TECHNICAL MEMORANNDUM REGARDING RESPONSE TO COMMENTS ON DRAFT
PHASE I VAPOR INTRUSION INVESTIGATION REPORT OPERABLE UNIT 1 (OU1) MCAS
CHERRY POINT NC
10/18/2010
CH2MHILL

Response to Comments

Draft Phase I Vapor Intrusion Investigation Report

Operable Unit No. 1

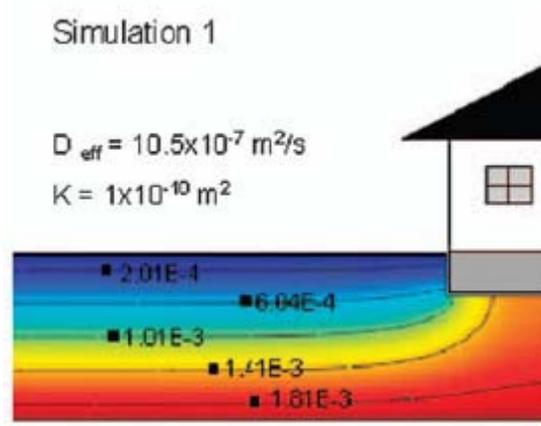
Comment 1: Buildings 133 and 137 were the only buildings in this phase of investigation that had subslab soil gas samples collected inside the buildings. Eight of eight of these subslab 'in the building' soil gas samples had detections in excess of the screening values. The majority of groundwater and soil gas samples collected through paving adjacent to buildings did not have exceedances of the screening values. As a general observation, there were some soil gas samples taken above the groundwater plumes (as defined by the figures in Section 2) that had no exceedances of the screening values and some soil gas samples collected above areas outside the plume boundaries that did have exceedances of the screening criteria.

As comprehensive and organized as this document is, it appears to have a short coming in the conceptual site model (CSM). A key point in the generic vapor intrusion CSM is the chimney effect. Simply, the presence of a building concentrates vapors in the subsurface below the building. The figure directly below illustrates this concept, keeping in mind that the 3 values on the figure are from the article and are not related to MCAS Cherry Point.

Response 1: While reference to the chimney effect is respectfully acknowledged, this effect is unlikely the driver behind the elevated subslab concentrations detected beneath Buildings 133 and 137 and the differences observed between subslab and exterior results. As discussed in Section 2.2.4, the VOC releases at Building 133 have been determined to be related to the historical sump within the building and the drainage ditches that were subsequently covered as the building was renovated and expanded. Building 133 was targeted for subslab sampling knowing that: 1) the subslab soil gas concentrations would likely be higher beneath the building based on the interior locations of the primary VOC source areas; 2) the two TCE groundwater “hot spot” plume areas are beneath the building footprint (see Figure 2-5); and 3) exterior soil gas concentrations (even right above the water table) would likely not predict subslab concentrations. The results confirmed these assumptions.

As discussed in Section 2.4, there is a distinct TCE groundwater plume located entirely beneath building 137 (Figure 2-5) and for similar reasons discussed above, building 137 was targeted for subslab soil gas sampling during the Phase I investigation. Subslab concentrations beneath building 133 were expected to be different than exterior soil gas samples and this was confirmed based on the Phase I data. The report will be clarified to explain the rationale for subslab sampling at these two buildings, along with some additional discussion to supplement the CSM writeup. The figures will also be updated to show the location(s) of the likely primary vapor sources beneath buildings 133 and 137 (e.g., the sumps and drainage ditches).

The distribution of soil gas concentrations shown in the figure the commenter provided above is only one of the multiple modeling simulations performed by EPA as they develop their vapor intrusion conceptual model scenario document that will be released shortly. As presented at the USEPA March 2010 workshop on vapor intrusion (<http://iavi.rti.org/WorkshopsAndConferences.cfm>), the Abreu and Johnson 3D vapor intrusion model can be used to illustrate the effect of various site conditions on the fate and transport of vapors in the subsurface and into buildings.
